United States Patent and Trademark Office

APPLICATION NO.	FILING DATE	FIRST NAMED INVENTOR	ATTORNEY DOCKET NO.	CONFIRMATION NO.
09/374,681	09/19/2002	CRAIG H. BAKER	81762/210	4027
75	90 06/02/2005		EXAMINER	
GUNNER G. LEINBERG, ESQ.			TSUKERMAN, LARISA Z	
NIXON PEABODY LLP CLINTON SQUARE			ART UNIT	PAPER NUMBER
P.O. BOX 31051			2833	
ROCHESTER, NY 14603			DATE MAILED: 06/02/2005

DETAILED ACTION

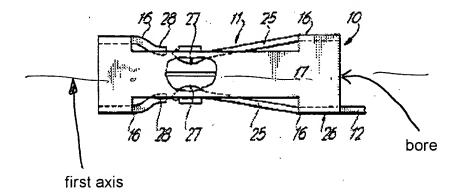
an electrically conductive body 11 having a pin contact engaging bore (not marked, see Attachment) which extends at least partially along a first axis, the body 11 comprising:

at least two pin contact arc receiving elements 18 (see Attachment 1, read on applicant's left and right guide portions 18) extending into the bore, wherein the arc receiving elements 18 are spaced apart across the bore and having a distance that is greater than a maximum transverse dimension of the pin contact 20 (shown in Fig.3), and

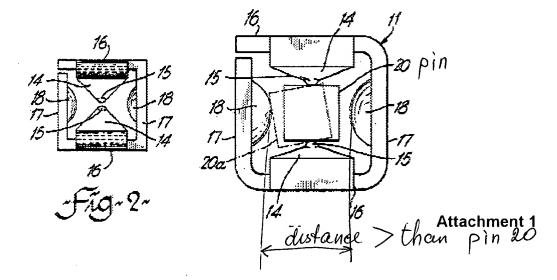
a plurality of conductive spring contacts 14 spaced from and not aligned with the arc receiving elements 18 in a direction along the first axis of the bore and which extend in towards the first axis.

In regard to claims 2, 9 and 15, Ostapovitch also discloses an aperture (not marked, see Fig. 3) defined in the body 11, which extends through the bore and spaced from the spring contacts 14 along the bore.

In regard to claims 3 and 10, Ostapovitch also discloses the pin contact arc receiving elements 18 comprises stamped or curved inwardly extending projections (Fig. 1 and 3 and Attachment 1).
